Addendum #1 to Final Environmental Impact Report for the
Glen Mor 2 Student Apartments Project
(SCH# 2010081020)

Project Title: Glen Mor 2 Student Apartments
Project Number: 956334
Project Location: The project is located on the University of California, Riverside (UCR) campus, generally northwest of Big Springs Road and Valencia Hill Drive. The site is south of the existing Glen Mor 1 and Pentland Hills residential complexes and east of Lothian residence hall.
City: Riverside
County: Riverside

Addendum #1 for Glen Mor 2 Student Apartments
Modified Arroyo Improvements
September 25, 2012

Figure 2-5
Proposed Arroyo Improvements
Glen Mor 2 Student Apartments
Revised September 2012 for Arroyo Improvements Addendum

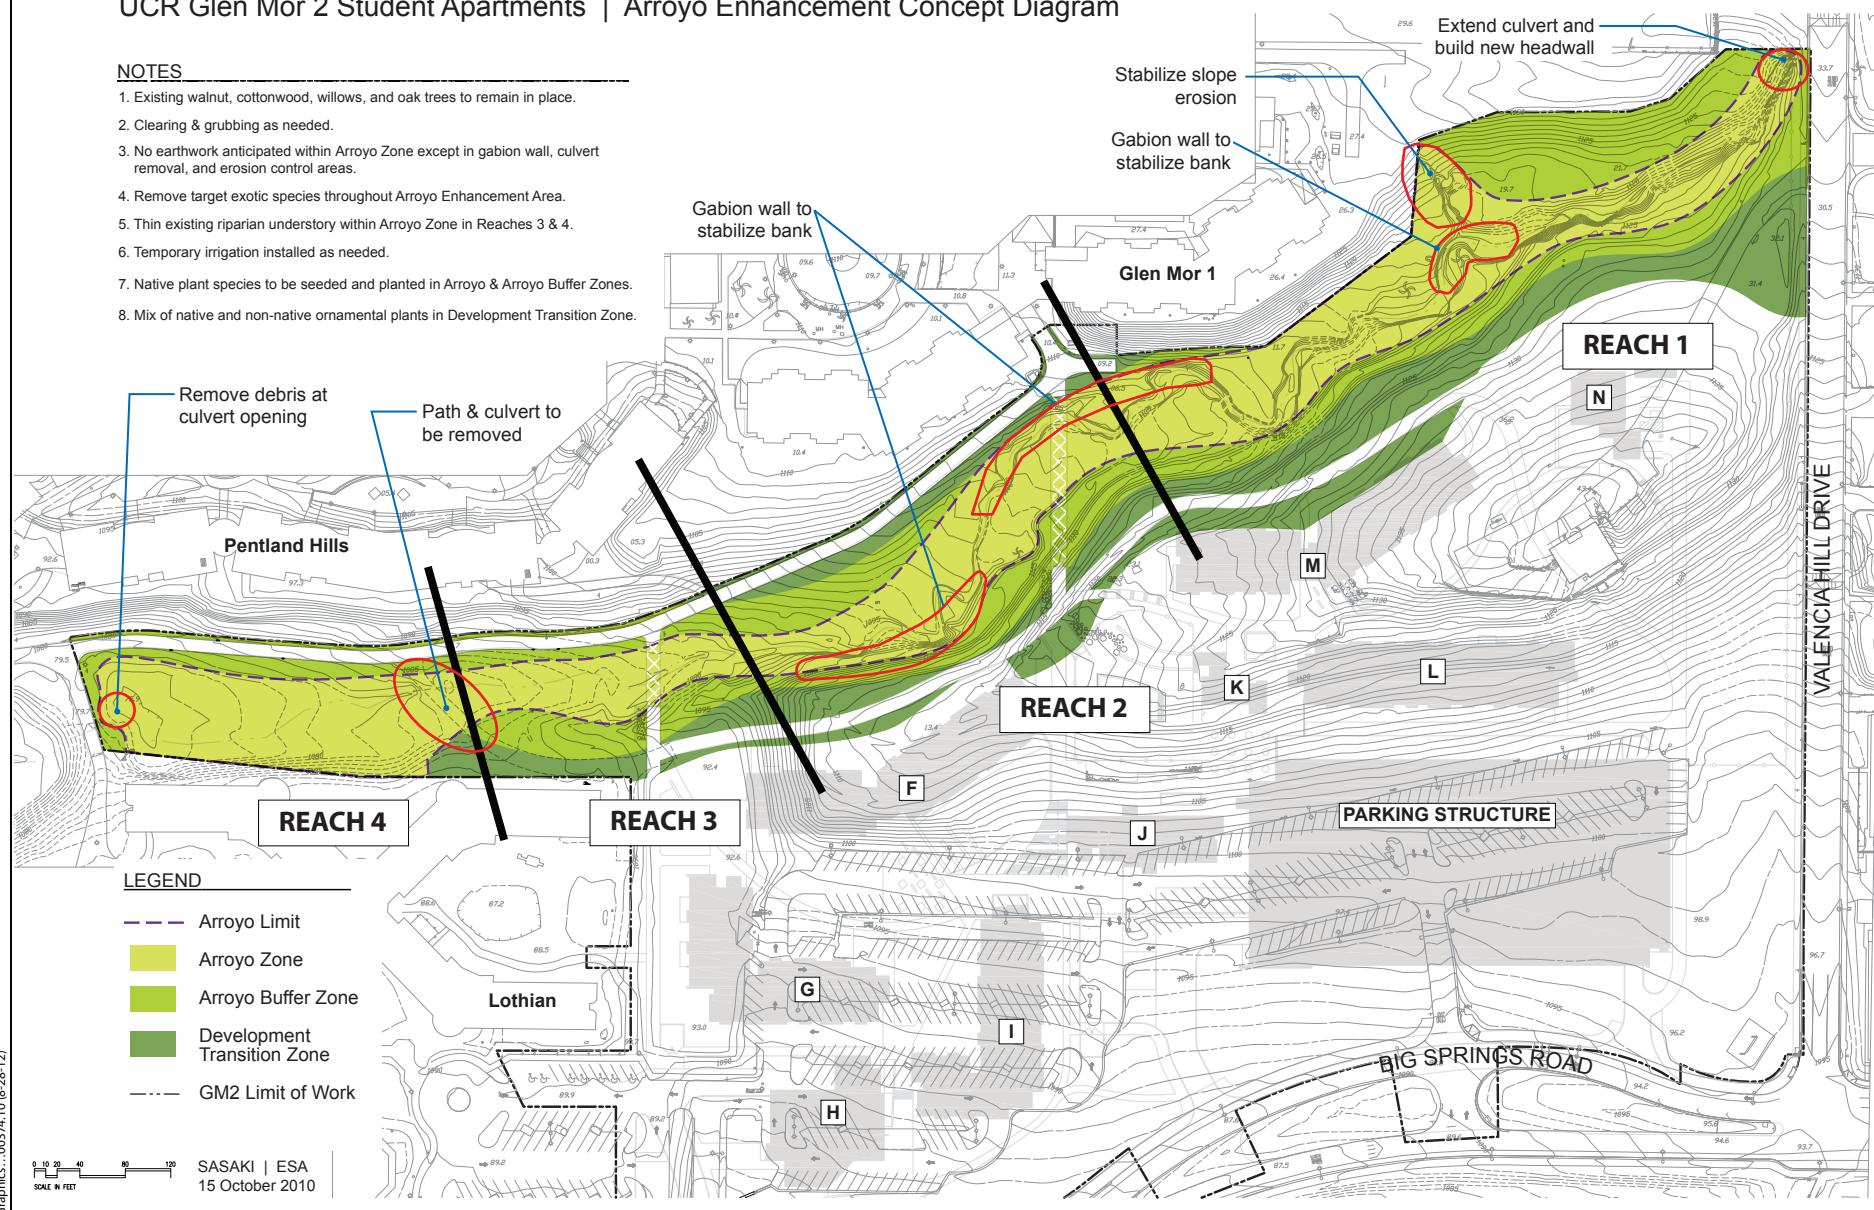
A. Bank stabilization at three locations along the arroyo – two on the north bank and one on the south bank. The nature and extent of these improvements has intensified from that anticipated at the time of preparation of the certified EIR. The improvements as previously proposed were based upon a 2008 topographic survey as to conditions along the arroyo. Based upon existing conditions the civil and geotechnical engineers have recommended an enhanced program of improvements to stabilize the arroyo banks. The current recommendations include:

Upstream Gabion Wall – entails approximately 125 feet of gabion wall along the north arroyo bank, south of the Glen Mor 1 recreational fields. At this location, the gabion wall would be up to 4 feet in height above finished grade, with an additional depth of wall extending approximately 6 feet below grade for scour protection. The face of the gabion wall would closely follow the existing bank along the downstream half of the wall, with the upstream half situated within a bench outside the existing stream zone. The erosional feature extending landward toward the recreational fields would be backfilled to establish a uniformly sloping finished ground surface.

Central Gabion Wall – entails approximately 250 feet of gabion wall along the north arroyo bank, just south of Glen Mor 1 and Pentland Hills. At this location, the gabion wall would be up to 6 feet in height above finished grade, with an additional depth of wall extending approximately 6 feet below grade for scour protection. The position of the proposed wall meanders both landward and streamward of the existing arroyo bank. Where the wall is placed within the existing streambed, grading will provide compensating channel bottom width and establish a new bank on the opposing side.

Downstream Gabion Wall – entails approximately 225 feet of gabion wall along the south arroyo bank, upstream of the shorter of the two proposed bridges. At this location, the gabion wall would be up to 9 feet in height above finished grade. Where exposed wall height is 6 feet or less there is an additional depth of wall extending approximately 6 feet below grade for scour protection. Where exposed wall height exceeds 6 feet there is an additional depth of wall extending approximately 9 feet below grade for scour protection. The proposed work would complete a flowline transition along a snaking section of the channel at the upstream end of the proposed wall section that has been substantially accomplished by natural processes. In the central portion of the new wall, a shallow bench along the existing flowline would be excavated to broaden the channel bottom. Grading would recontour the channel bottom along most of the length of the wall and establish a new north bank along the downstream half.

Figure 2-7
Tree Removal Plan
Glen Mor 2 Student Apartments
Revised September 2012 for Arroyo Improvements Addendum

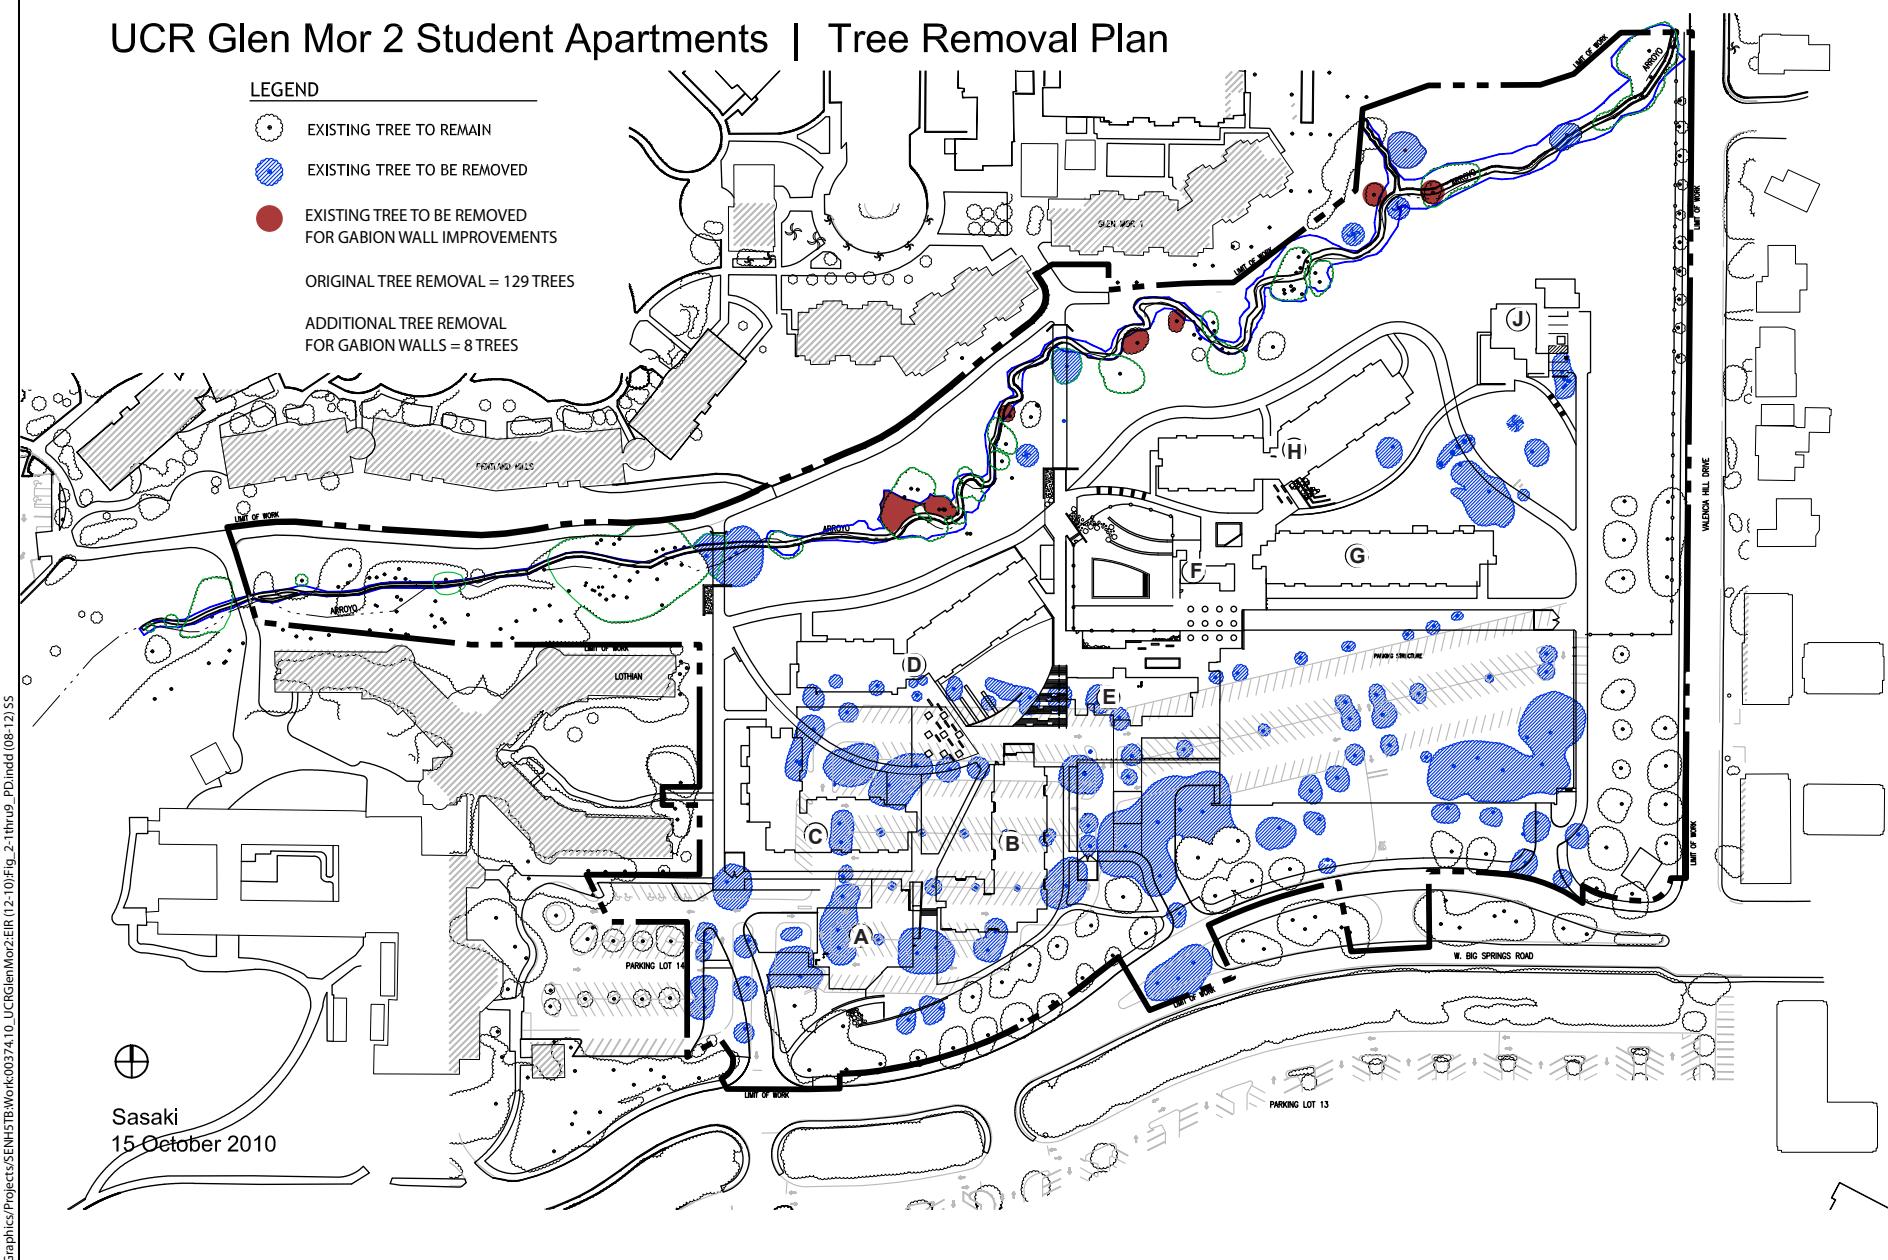
The updated assessment of temporary impacts to riparian habitat includes potential loss of the mature cottonwood tree at the Valencia Hill Drive culvert extension. Adopted Mitigation Measure BIO 3 requires minimization of temporary construction impacts and specifically identifies avoidance of this cottonwood tree. Review of field conditions and detailed design plans as part of ongoing project mitigation monitoring has identified a substantial encroachment into the root zone of this tree. The arborist and landscape architect reviewing these circumstances cannot say with certainty that the tree will survive the proposed construction activity. Based upon the recommendations of the arborist and landscape architect, modifications to adopted mitigation measures BIO 3 and BIO 4 are included as part of this action to elaborate upon construction avoidance measures and to specify replacement plantings in the event the tree ultimately fails (see September 12, 2012 ICF memorandum and modified versions of mitigation measures attached hereto). The discussion of impacts upon riparian habitat in the certified EIR (page 3.3-13 of the Draft EIR Volume) acknowledges temporary impacts associated with removal of riparian habitat in the arroyo zone and concludes that the restoration of disturbed functions and values through Mitigation Measure BIO 4 would reduce impacts to less than significant. This mitigation measure is also applicable to potential loss of the cottonwood tree.

Figure 3.3-4
Vegetation Community Impacts
Glen Mor 2 Student Apartments
Revised September 2012 for Arroyo Improvements Addendum

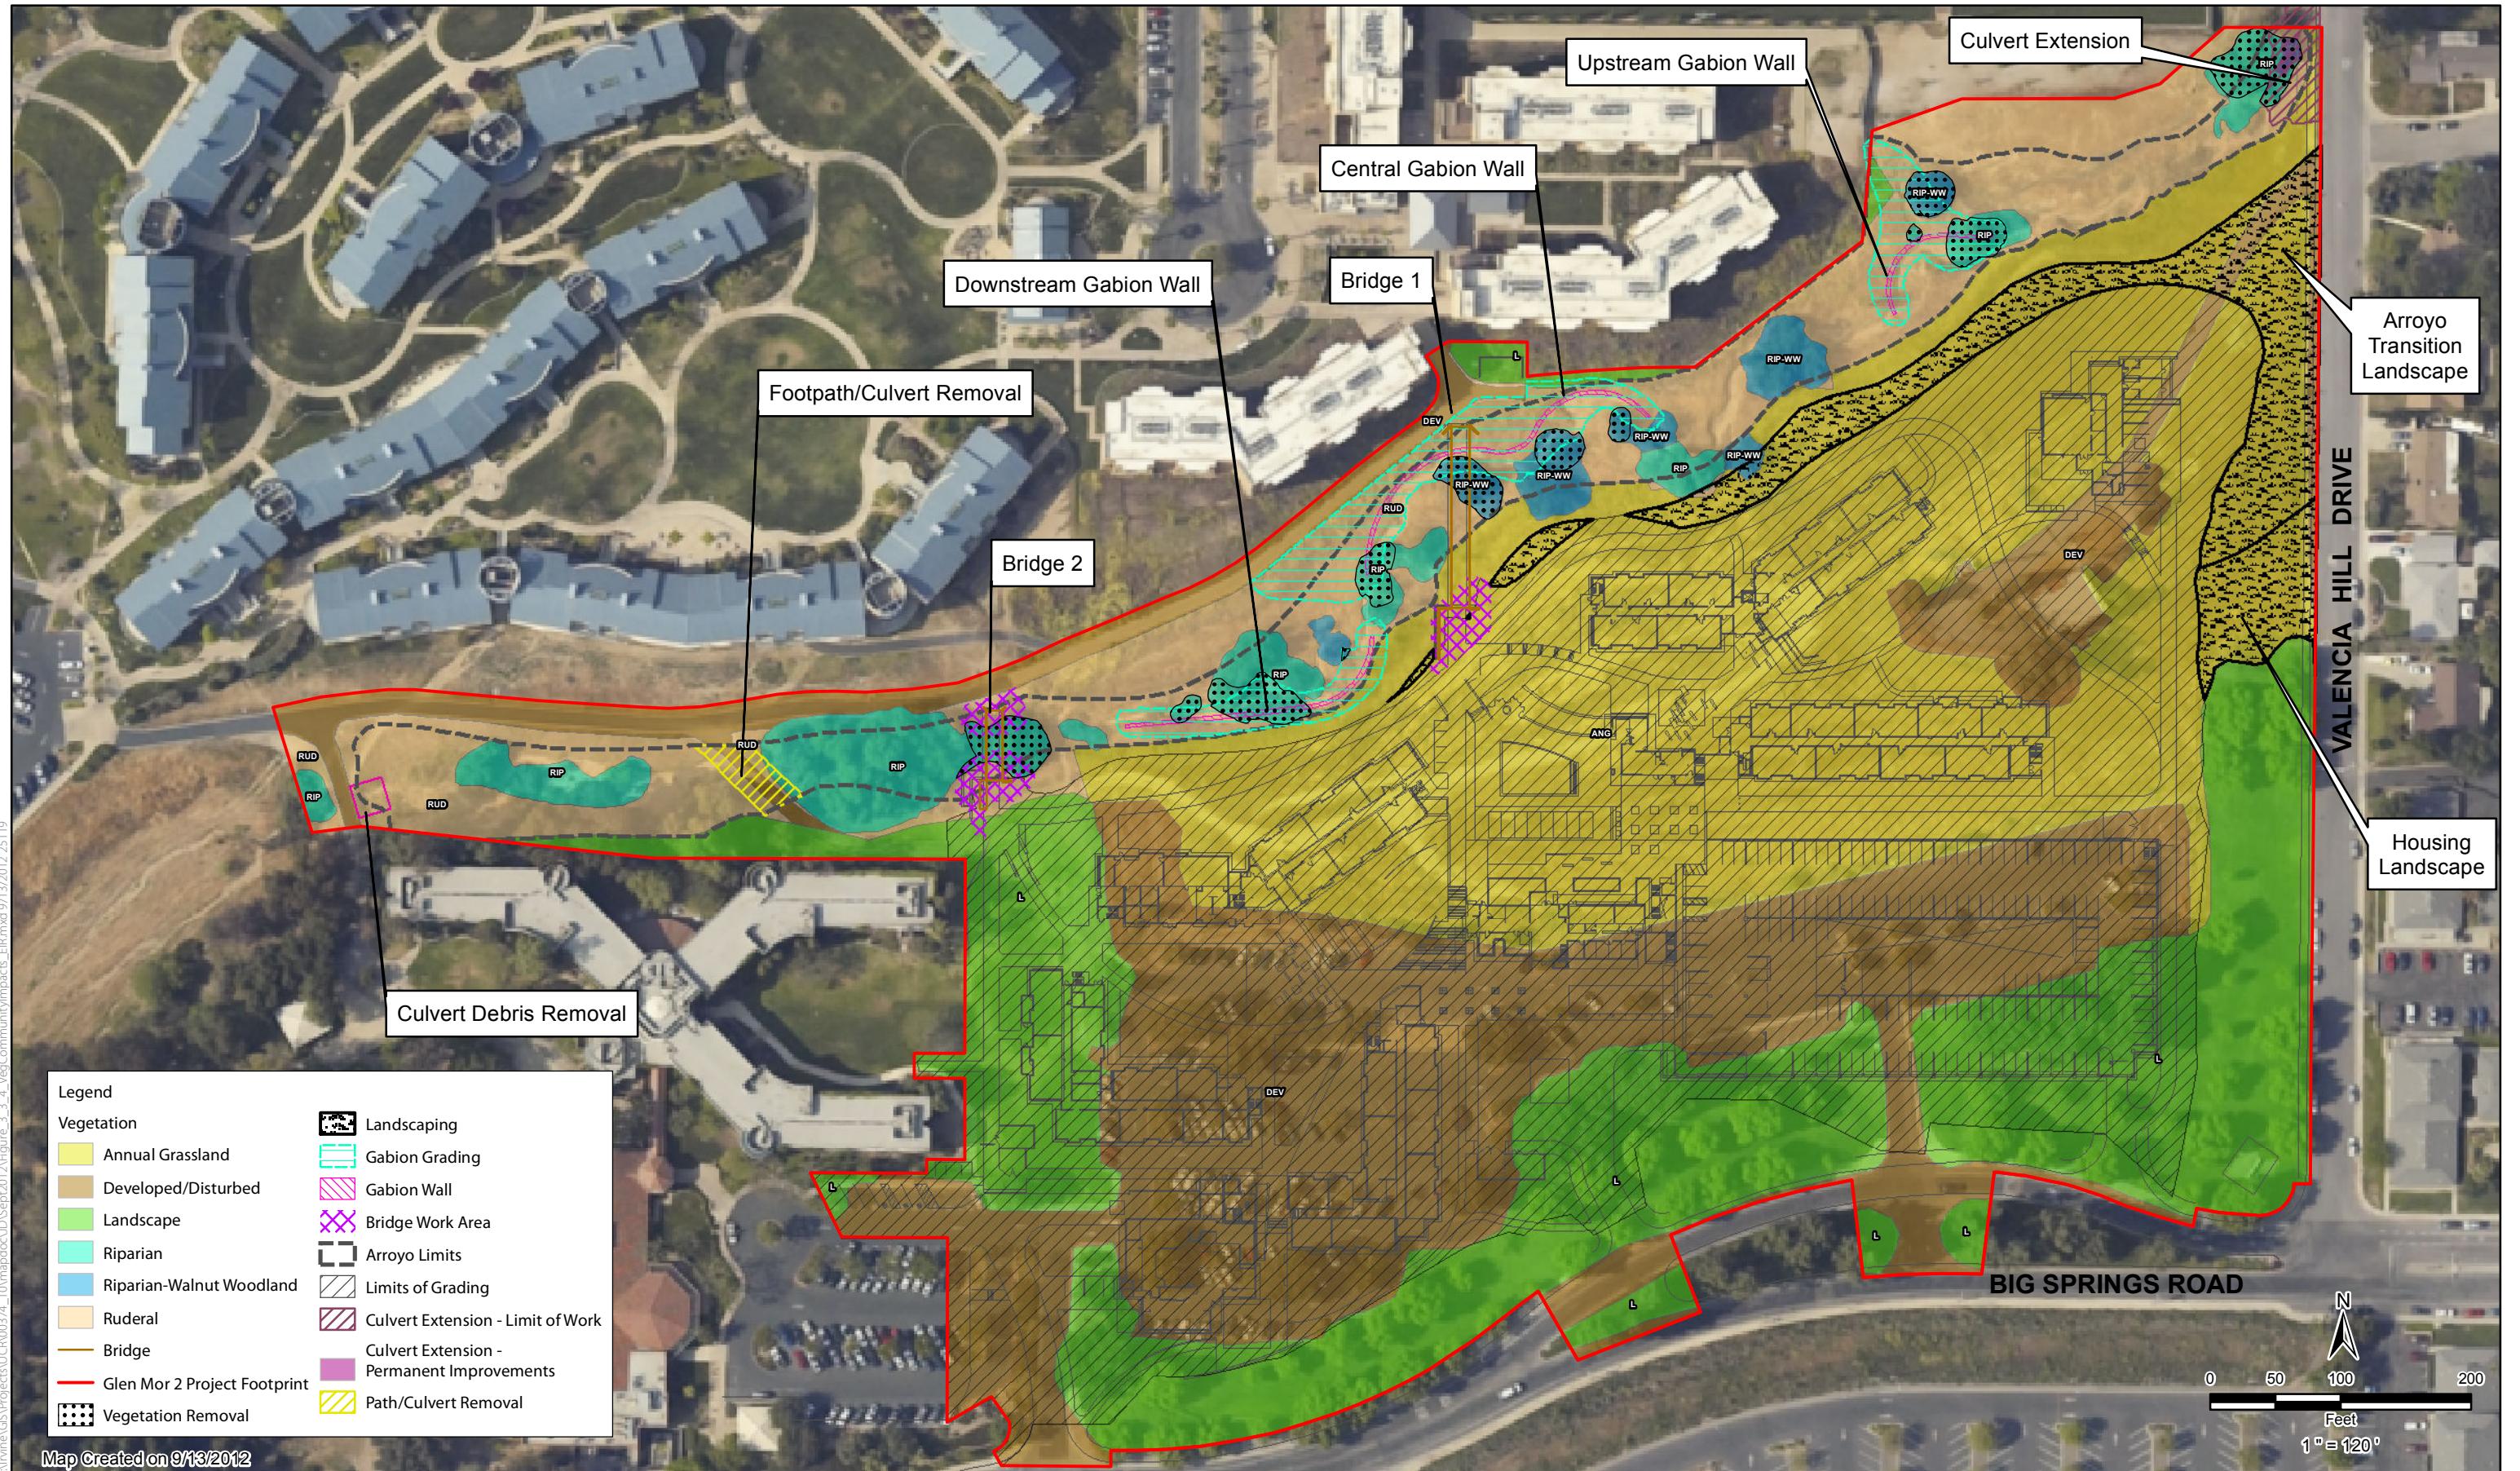
Note: Vegetation Removal limits at the Culvert Extension adjacent to Valencia Hill Drive reflect the possibility that the large cottonwood tree at this location may be lost due to work within the tree's root zone. Monitoring activities during and after construction will be directed at preserving this tree in accordance with MM BIO 3. However, in the event the tree fails despite all reasonable measures, replacement plantings will be implemented in accordance with MM BIO 4.
